**To:** Richard Collier, McKim & Creed  
**From:** Brian Chambers, Senior Planner; 910.342.2782  
**CC:** File;  
**Date:** 7/13/2022  
**Re:** Center Point TRC Rev 4

Project Name: Centerpoint  
Response Date: 07/13/2022  
Reviewer: Eric Seidel, PE  
Department: Engineering – Plan Review Section

**PROJECT NAME: CENTER POINT TRC PLAN**

REVISIONS	CS-100
NO.	12
DESCRIPTION	
BY	
DATE

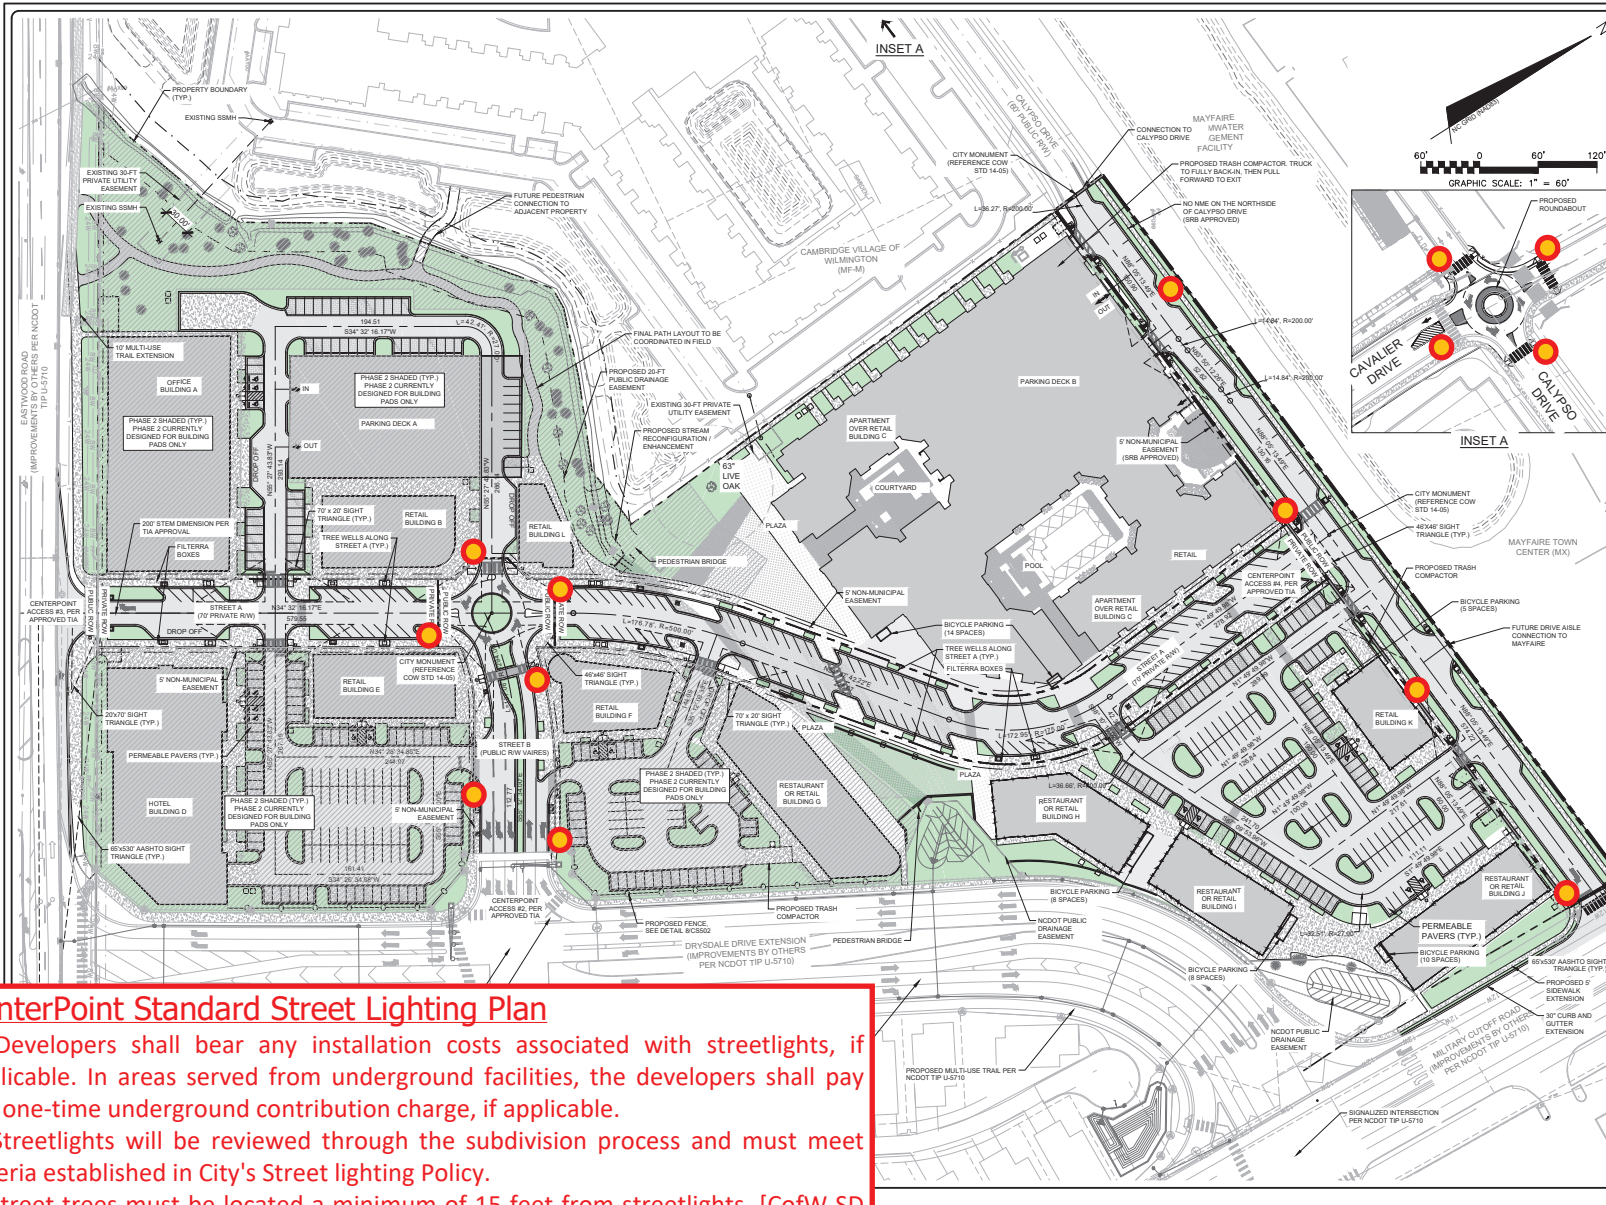
8. A revised layout for the Standard Street lighting on proposed City maintained public ROWs has been provided with this revision. Minimum of 14 (Fourteen) LED50 streetlights are required for this sub-division and roundabout at Calypso Dr/Cavalier Dr. Subject to change based on the study by DEP.

11. As per City streetlighting policy, Streetlights are required on all the public streets within City limits. Streetlights shall be installed on the street sections of Eastwood Rd and Drysdale Dr Extension abutting this project.

14. Streetlights are required to be installed along abutting streets of Eastwood Rd, Drysdale Dr extension and Military Cutoff Rd as a part of this development. Contact Duke Energy to get the plans developed in compliance with AASHTO standards.

● Proposed locations of required 14 LED 50.  
Locations may vary as per the field survey by DEP.
